UNITED STATES PATENT AND TRADEMARK OFFICE

APPLICATION NO.	FILING DATE	FIRST NAMED INVENTOR	ATTORNEY DOCKET NO.	CONFIRMATION NO.
10/523,768	02/08/2005	Johann Robert	1200.725	2672

Office Action Summary

JOHANN ROBERT

Fig. 2

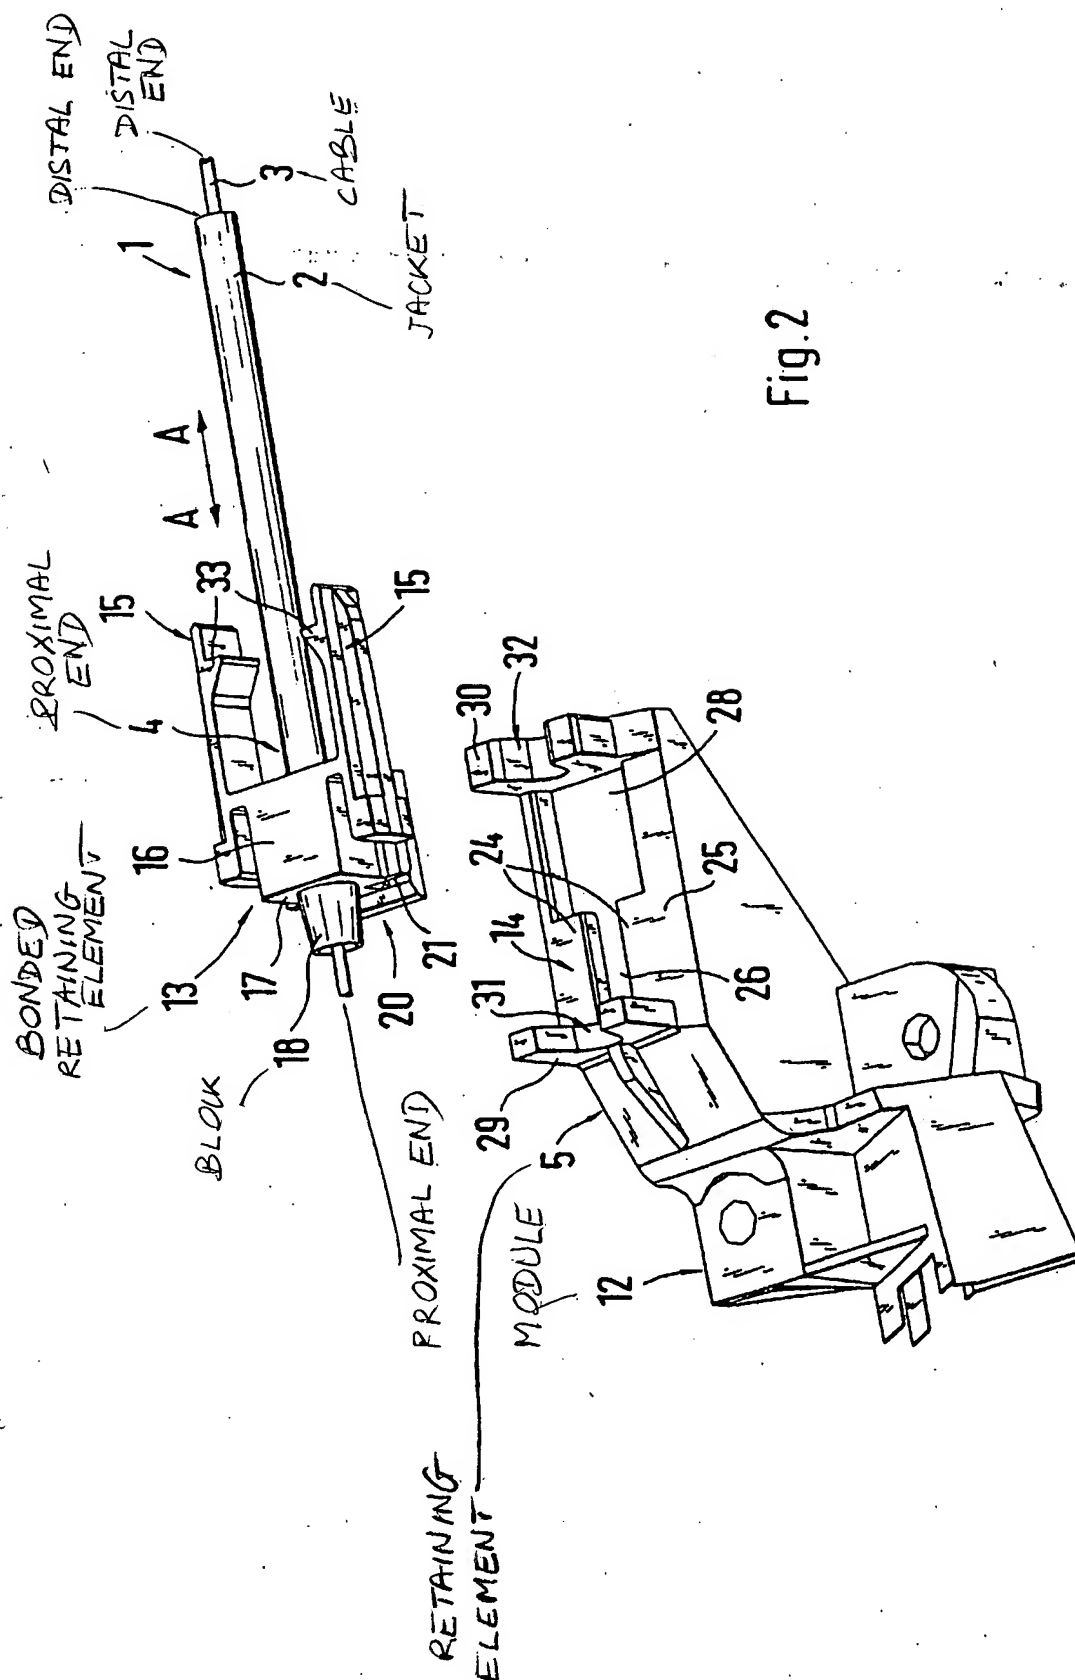
Regarding Claim 1, Gutschner teaches a control device for a module 12 forming a lock mechanism, of the type comprising a Bowden-type cable containing a cable 3 having two ends, a proximal end (see Attachment hereinafter "Att.") and a distal end (Att.) respectively, this cable 3 being housed in a jacket 2 having two ends, a proximal end 14 and a distal end (Att.) respectively, which are immobilized by two proximal and distal retaining elements 13 and 5, characterized in that *at least* one of the ends of the jacket 2 is connected to the corresponding retaining element 13 by adhesive bonding (*i.e.*, gluing. *Ibid.* col. 2, lines 61-64), the bonded retaining element 13 being provided with a part 16 forming a sleeve 16 for fitting the bonded end 4 of the jacket 2, the sleeve-forming part 16 containing an orifice (FIG. 4 of Att.) which is substantially transverse to the direction in which the bonded end 4 of the jacket 2 is fitted, this orifice (FIG. 4 of Att.) forming a receptacle (FIGS. 4 and 6) *for* holding a mass of adhesive in contact with the jacket 2 and the bonded retaining element 13.

Regarding Claim 6, the proximal end (FIG. 2 of Att.) of the cable 3 is provided with a block 18 for securing this cable 3, the shell 20, 27 forming a housing for this securing block 18.

Regarding Claim 9, Gutschner teaches a method of adjusting a Bowden-type cable containing a cable 3 having two ends, a proximal end (FIG. 2 of Att.) and a distal end (Att.) respectively, this cable 3 being housed in a jacket 2 having two ends, a proximal end 4 (Att.) and a distal end (Att.) respectively, this jacket 2 being *intended to be* immobilized by two proximal 13 and distal 5 retaining elements, characterized in that: the length of the proximal end (Att.) of the cable 3 protruding outside the jacket 2 through the proximal end 4 of the latter is adjusted, then the proximal end 4 of the jacket 2 is fastened to the proximal retaining element 13 by adhesive bonding. *Ibid.* col. 2, lines 51-64 and Claims 1-4.

Fig.4

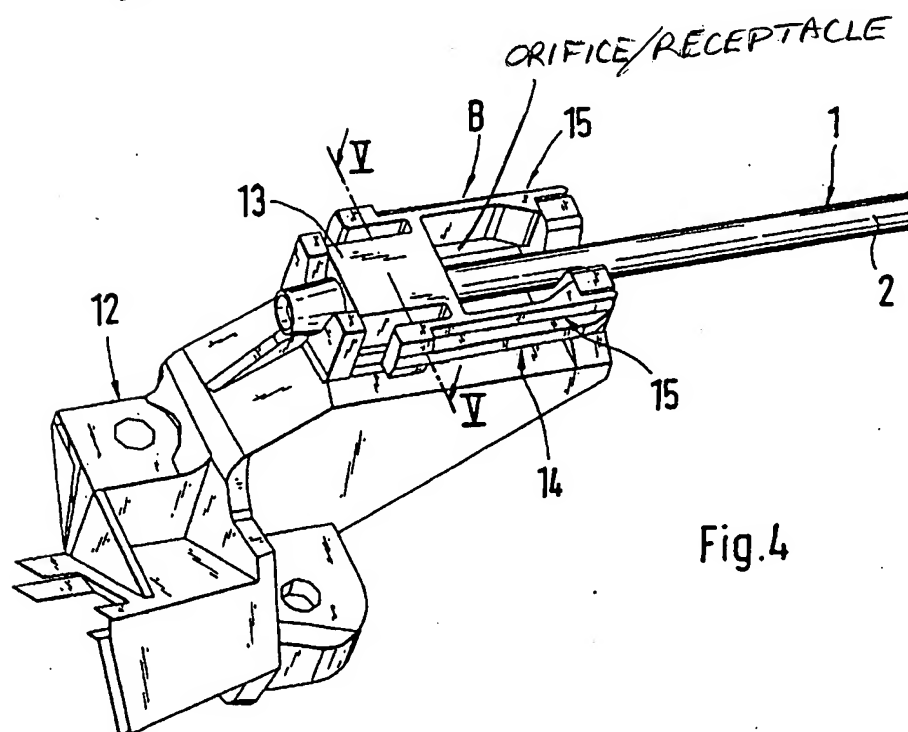
Regarding Claim 4, the edges of the orifice (FIGS. 4 and 6) are provided with projecting or recessed reliefs 33.
